SUBMITTAL IDENTIFICATION SHEET

WEBSTER UNIVERSITY ISB	
PROJECT NAME	
8274 BIG BEND BLVD	
ADDRESS	
NUMBER	
WEBSTER UNIVERSITY	
OWNER	
CANNON DESIGN	
ARCHITECT / ENGINEER	
DEVIN D GATES	
SUBMITTED BY	
092900-013	
CONTRACTOR / CM SUBMITTAL NO.	CANNON DESIGN SUBMITTAL NO.
	092900
DRAWING / DETAIL REFERENCE	SPECIFICATION SECTION / PARAGRAPH
MANUFACTURER / SUPPLIER	ITEM / PRODUCT ID
REQUIRED DATE	PRIORITY
	CRITICAL

Extruded aluminum trim samples
 gordon 314-5/8, gordon 234, gordon 234
 gordon mullion mate
 gordon 911-EC 487, gordon 911-EC 375
 gordon 911-EC 600, gordon 911-EC 200
 Color chart (see RFI regarding colors)

POWDER COAT COLOR CHART

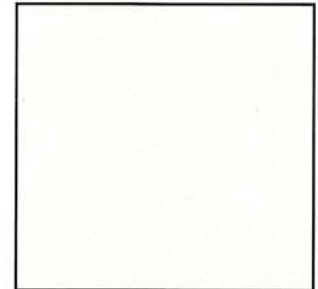
For the Mullion Mate and for the other extruded trims on the project, we would like one of the four available standard whites – please provide samples of all white colors from Gordon for selection. See markups.

Design intent is to select the one that most closely matches Sherwin Williams SW 7004 Snowbound.
